Ref: 24/01013/OP
Att: Sarah Kasparian

Land Surrounding Burloes Cottages, Newmarket Road, Royston, Hertfordshire,

Consultee comments;

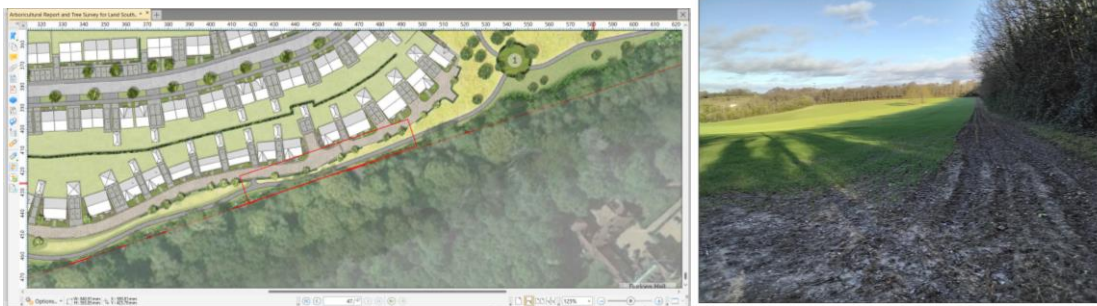
The red rectangle on the image below indicates approx. 12m buffer whereas actually less than 6m is shown on one of the most sensitive edges. Not only is this detrimental to wildlife but having homes in

such close proximity to woodland is also detrimental to householders being in overshadowed homes, particularly in the winter as the photo shows.

It would be preferable for any walking/ access route to be accommodated within the shared surface and the buffer to be widened and defined by a knee rail to deter car parking. The Arboricultural Report suggests that the holly trees (G10) along this edge which currently form an unmanaged hedge be maintained as a hedge. This would be beneficial both ecologically but also aesthetically and would help to control access to the woodland.
